Water Reduction Program Agreement Between the Sacramento River Settlement
Contractors Nonprofit Mutual Benefit Corporation, Individual Sacramento River
Settlement Contractors, and the U.S. Bureau of Reclamation Project

Final Environmental Impact Report

Prepared for Glenn-Colusa Irrigation District

Figure 1. Subsidence in Agricultural Lands Within the Colusa Subbasin (AquAlliance)

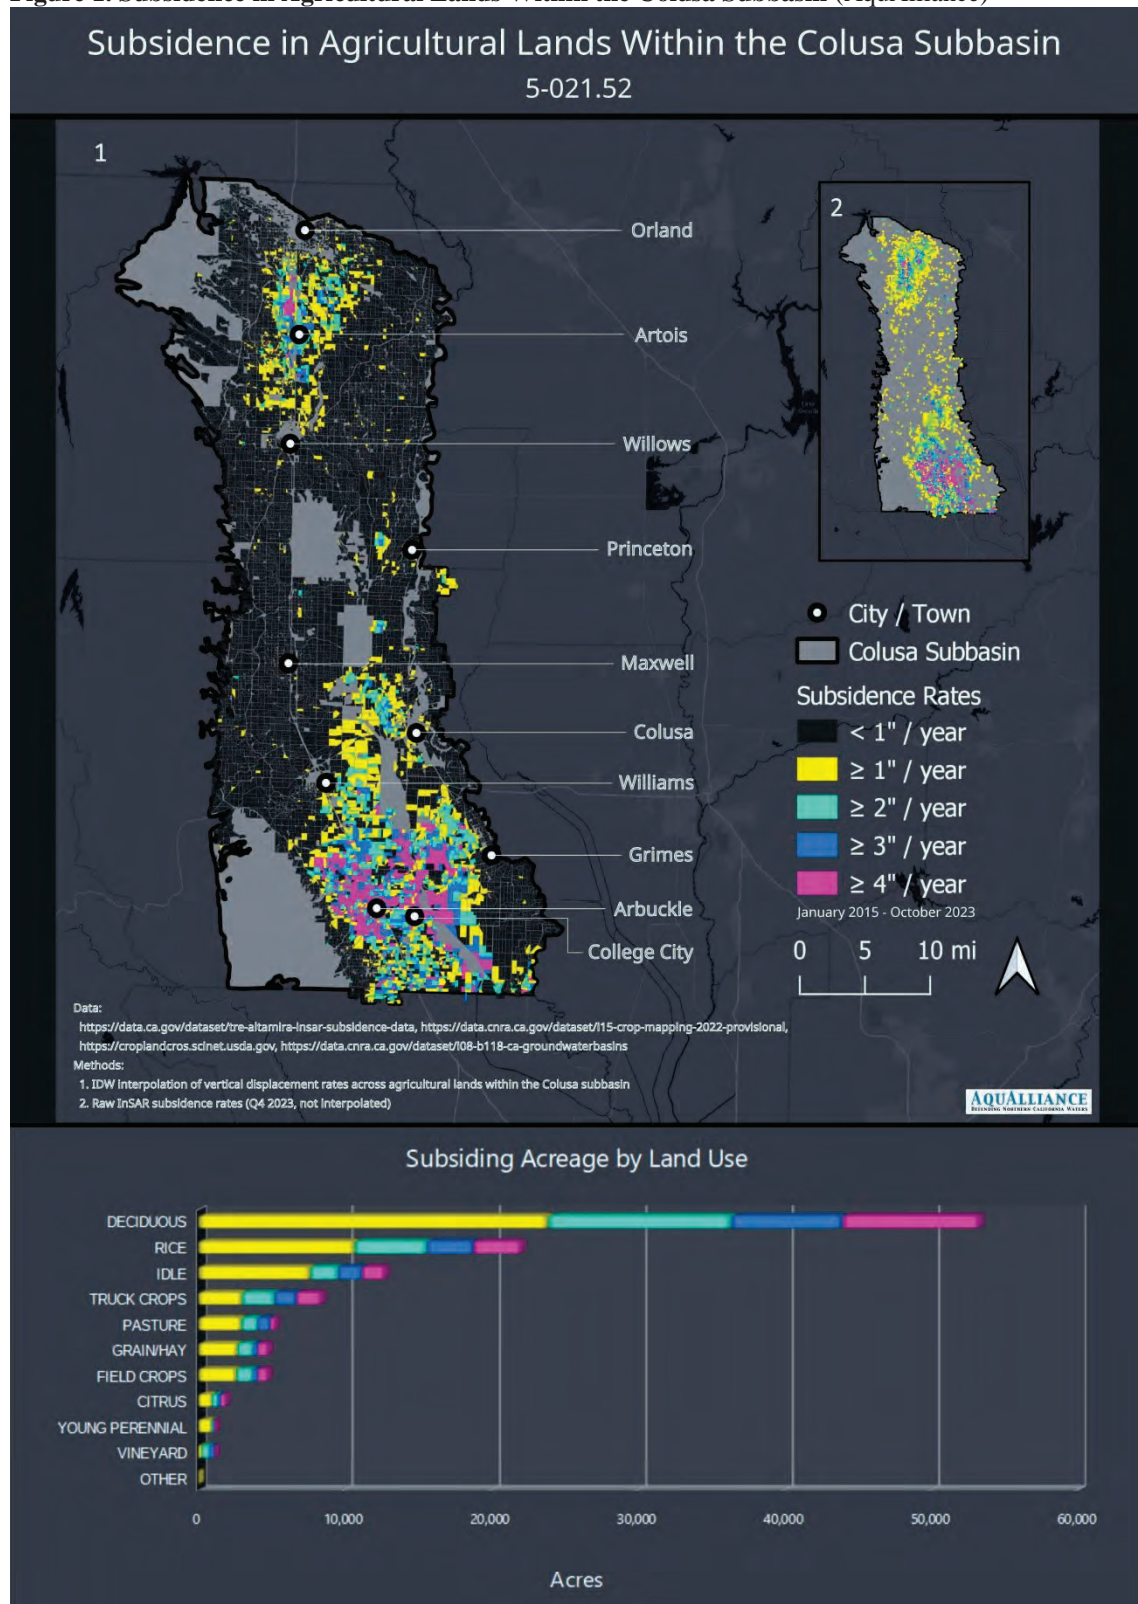
b) Figure 2 clearly illustrates the subsidence in the Colusa Subbasin. How does it compare with the GSP material? As one can see in the magenta areas, the land is collapsing at 4 inches per year, or a foot every three years. Knowing the land uses overlying the subsidence paints an interesting picture. What will the GSAs consider doing to stop the actors causing it?

Figure 1. Subsidence in Agricultural Lands Within the Colusa Subbasin

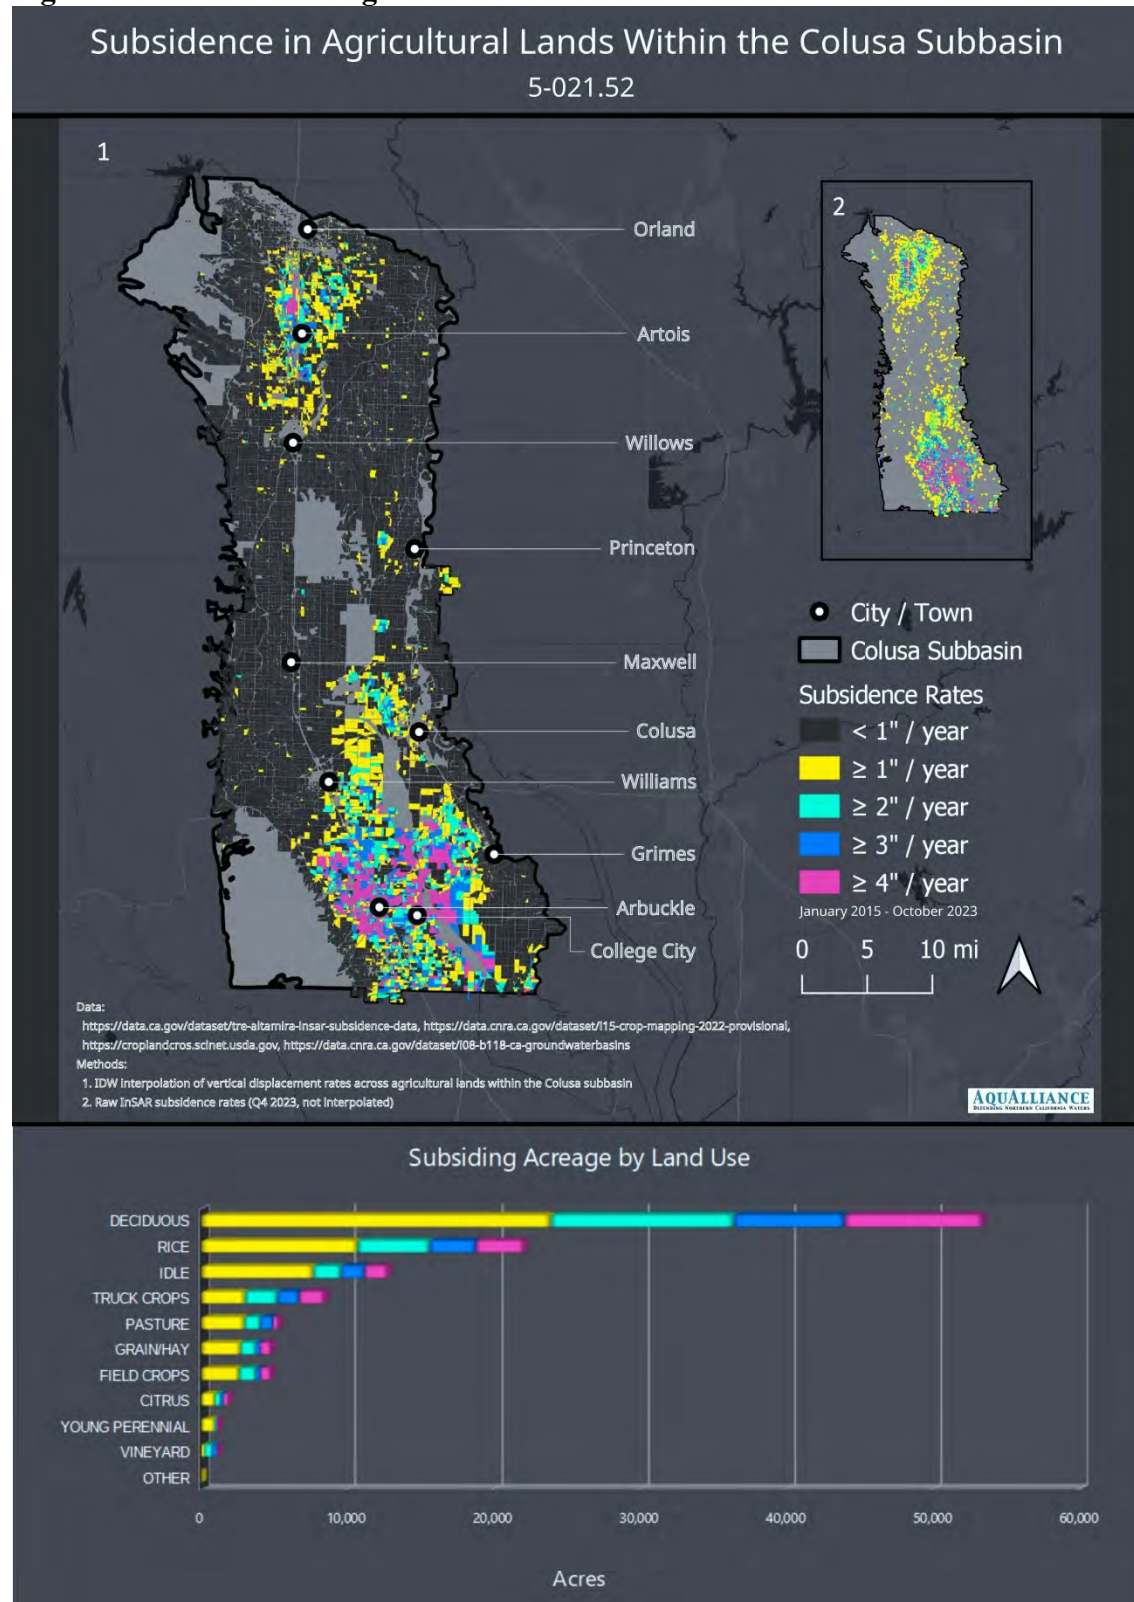
b) Figure 1 clearly illustrates the subsidence in the Colusa Subbasin. How does it compare with the GSP material? As one can see in the magenta areas, the land is collapsing at 4 inches per year, or a foot every three years. Knowing the land uses overlying the subsidence paints an interesting picture. What will the GSAs consider doing to stop the actors causing it?

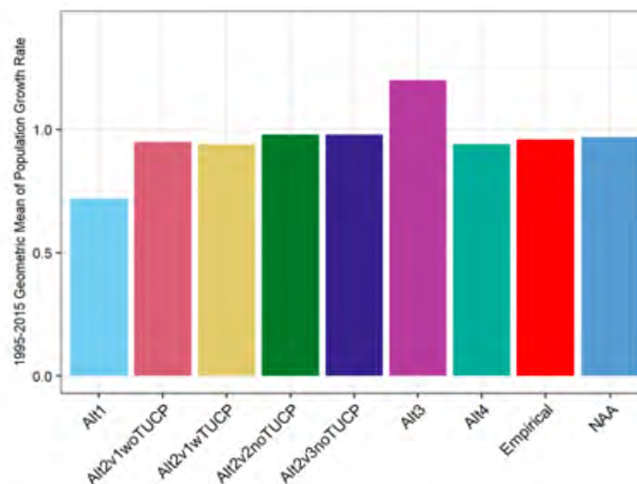
The Delta Smelt LCM analysis clearly demonstrates that Alternative 3 substantially outperforms all other alternatives with respect to estimated future population growth rates (DEIS, Figure 1; Attachment F.4, Table F.4-5 and Figure F.4-9). In fact, Alternative 3 is the only alternative that produces positive Delta Smelt population growth rates on average. Negative average population growth rates shown in all other alternatives are consistent with inviable populations and extinction (McElhaney et al. 2002). Alternative 2 variants produce negative growth rates that are, on average, nearly indistinguishable from or worse than the NAA and empirical growth rates that have led to the near disappearance of this once abundant endemic fish species. Furthermore, all Alternative 2 variants perform worse than NAA or empirical results in Wet and Above Normal Years. The DEIS provides some insight into this result, explaining:

This demonstrates that Alternative 2 is not consistent with requirements of the ESA (especially given that Alternative 3 and non-alternative scenarios (“EXP1” and “EXP3”) demonstrate that operations that result in positive population growth are possible). Alternative 1 performs far worse than the NAA (Figure 1 below; *see also* DEIS, Attachment F.4 at Table F.4-5).

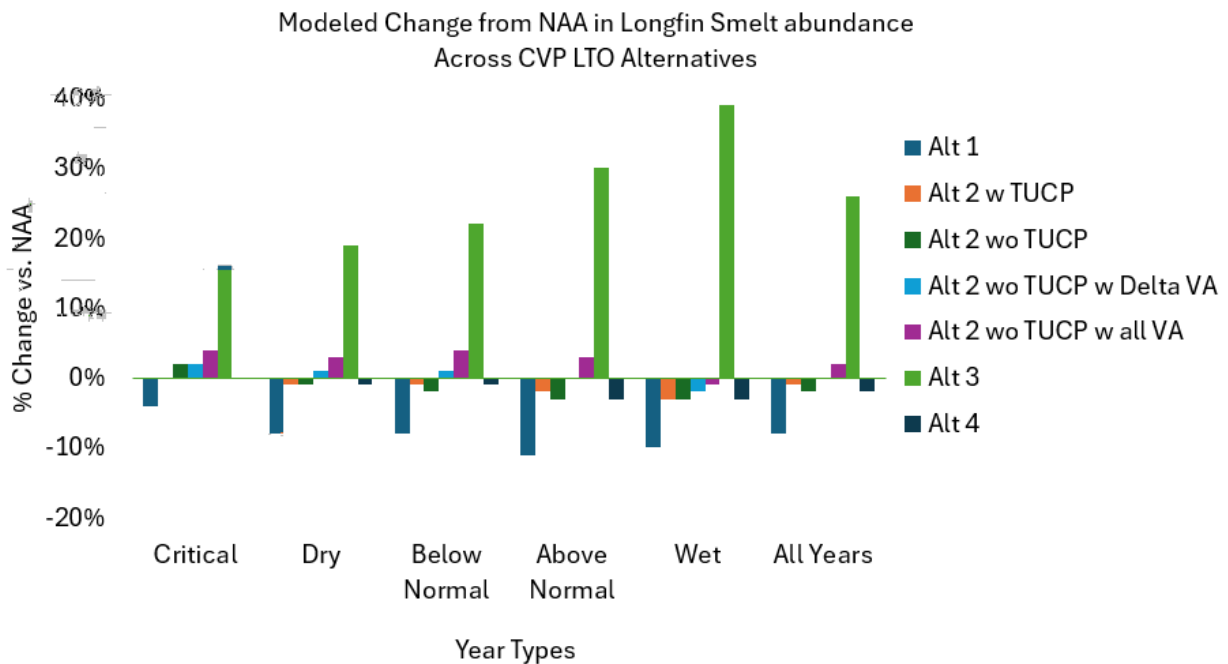
Moreover, a proper comparison of alternatives (i.e., comparing the *differences* in predicted annual Longfin Smelt abundance indices among alternatives) shows that the relative performance of different alternatives is very consistent. The fact that the Longfin Smelt population displays high variance (and that the 3-4 order of magnitude decline over time adds to this variance) does not mean that there is any uncertainty regarding the relative performance of Alternative 3 as compared to NAA. Notwithstanding the DEIS's statistically inappropriate efforts to minimize the different effects of the alternatives by comparing them to the variance within alternatives (e.g., as in DEIS Appendix AB-J attachment J, Figure J.1-2), Alternative 3 is superior to the NAA in *every year* modeled (Figure 3). The other alternatives are barely different

from the NAA during drier years (Figure 2) and when the estimated population is low (Figure 3), and their performance decreases relative to NAA as conditions become wetter and/or as the estimated annual population index increases. Under the NAA and all alternatives other than Alternative 3, the Bay-Delta Longfin Smelt population is likely to continue to decline to extirpation in the near future. Such an outcome is inconsistent with the requirements of both state and federal Endangered Species Acts.

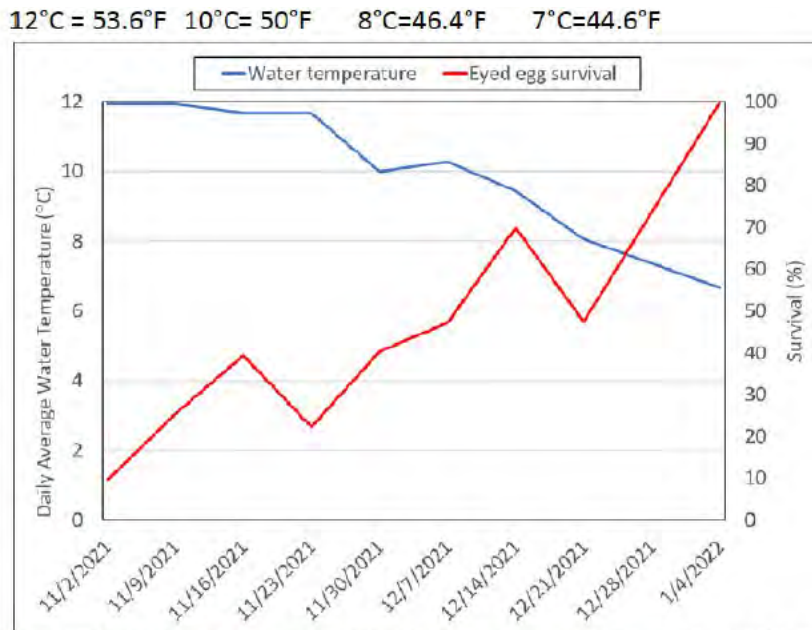
River hatchery were impacted by temperatures well below 56°F, but greater than 50°F (Figure 4).

Figure G3a-72. Trinity Reservoir End of April and End of September Storage (TAF) Percent Exceedance Plot

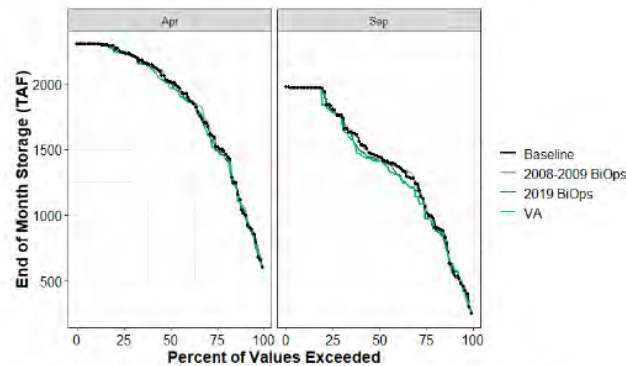
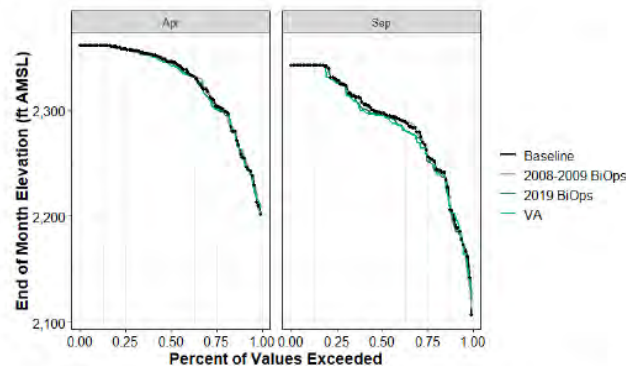
This impact is significant because coldwater storage in Trinity Lake is already impaired due to excessive water deliveries and climate change. **Mitigation for the Proposed Project's temperature impacts on Trinity Lake is required until completion of the separate Trinity River BA, BO and SEIS.**

Figure 4.4-56. Box Plot of Longfin Smelt April–May Salvage, from the Regression Including Mean Old and Middle River Flows (Grimaldo et al. 2009), Grouped by Water Year Type

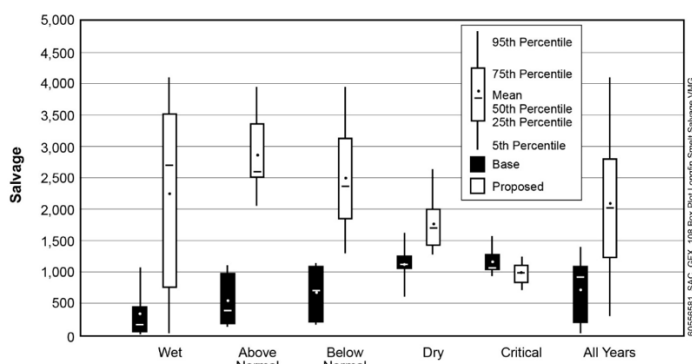
project operations, it must have a negative effect on overall abundance at some point. The DEIR projects very substantial increases – between 8% and 73.8%, depending on water year type – in salvage of juvenile Longfin Smelt from Proposed Project operations relative to the baseline (DEIR at Table 6-22 and Figure 6-52).

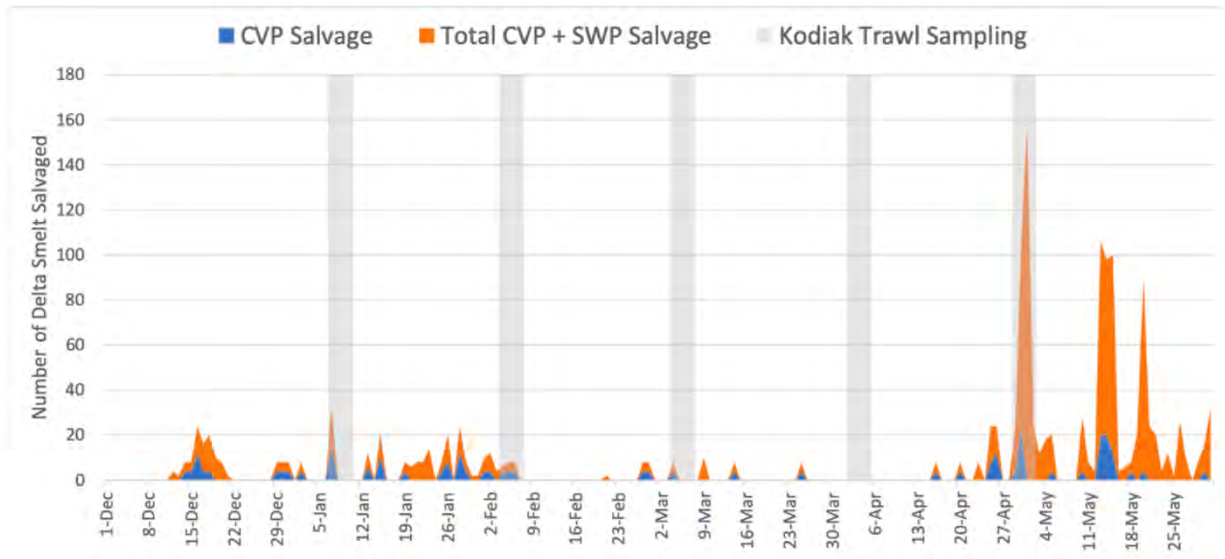
were salvaged (16, 11, 4, and 284 fish, respectively; Figure 1). This indicates that Longfin Smelt larvae and juveniles are susceptible to entrainment-mortality, even when sampling programs fail to detect them close to the export facilities.

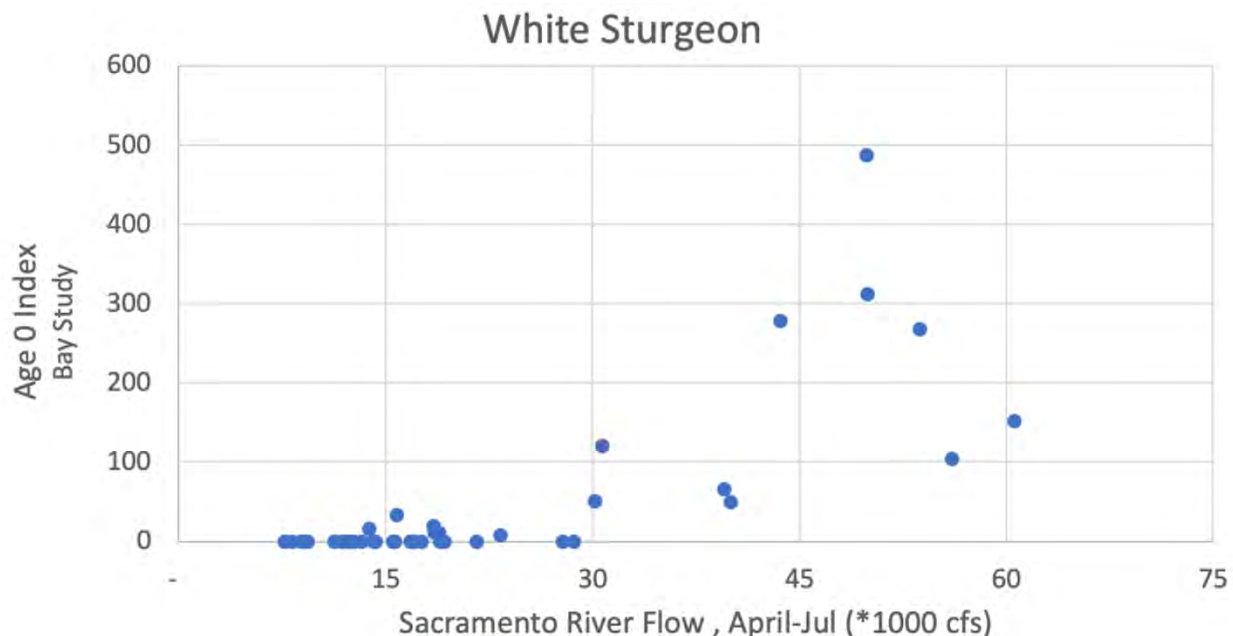
Furthermore, Baykeeper et al (2023) showed that recruitment of YOY White Sturgeon was very low or zero when Sacramento River flows (“SAC” + “YOLO” variables in Dayflow) average < 30,000 cfs between April and July (Figure 2).

Figure 3: Figure C-2 copied from Reclamation's Biological Assessment of Central Valley Project long-term operations; Appendix AB-C of Reclamation's DEIS for Central Valley Project long-term operations at p. 22 of the PDF.

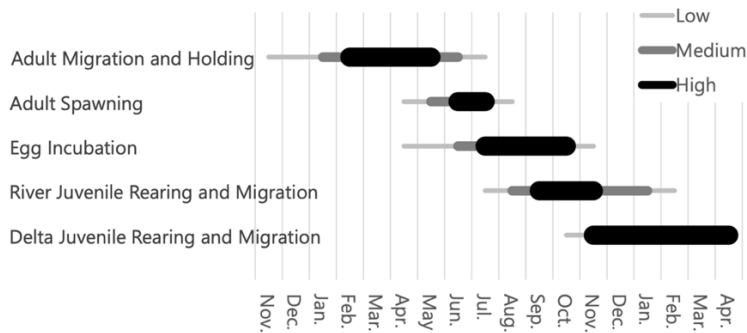
The relevant months for winter-run Chinook Salmon migration through and out of the Delta are October through April (Figure 3). The DEIR's application of the STARS model shows that winter-run Chinook Salmon through-Delta survival under the Proposed Project will be equal to or worse than the baseline in most years in October (Table 6-48 at 6-152), December (Table 6-50), and February (Table 6-52). Other months are projected to have survival rates that are less than or equal to the status quo in multiple water year types. In cases where analyses suggest the likelihood of increased survival relative to the status quo, such increases are tiny. As discussed above, it is very likely that river flows and Delta outflow will decrease and the negative effect of Delta hydrodynamics (e.g., increasingly negative OMR) will increase in years where project operations are governed by TUCO's and/or waivers/relaxed enforcement of ESA safeguards. Thus, expectations of through-Delta survival rates for winter-run Chinook Salmon are likely to be less positive in real life than they are in the DEIR's modeling.

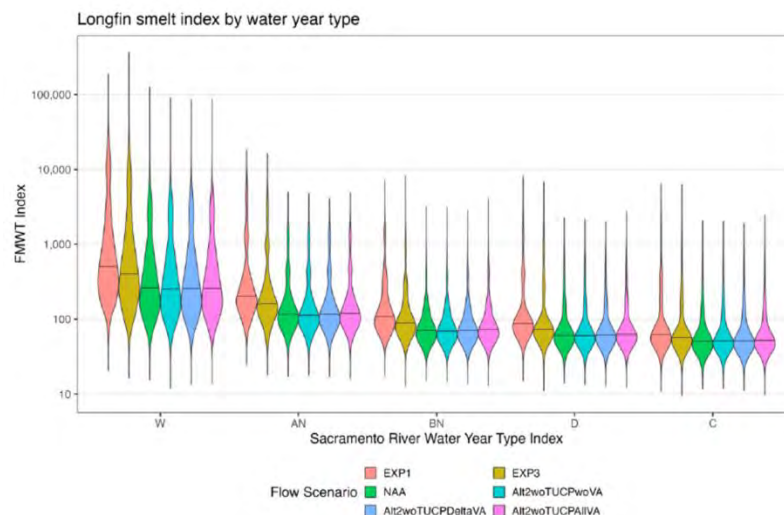
We ask that the Service share with us the model and methods used to generate the figure below and to reconsider how it interprets the very large differences shown in that figure in predicted outcomes of different management alternatives.

Figure 6-52. Exceedance Plot of Longfin Smelt April-May Salvage Prediction Interval, Based on the Analysis using the Salvage-Old and Middle River Flow Regression Developed by Grimaldo et al. (2009a)

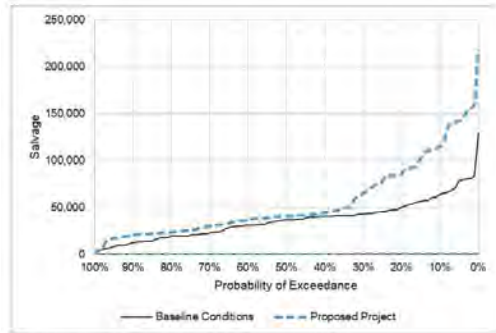
On top of these impacts (which are now the baseline for proposed reoperation of the CVP and SWP), even more negative OMR flows during April and May are expected to result from proposed CVP/SWP combined operations (SWP 2024 ITP DEIR at Figure 6-52, *see below*) and additional, very large increases in juvenile entrainment will result (SWP ITP DEIR at Table 6-22,

see below); larval entrainment during April and May should also be expected to increase under proposed CVP/SWP combined operations.
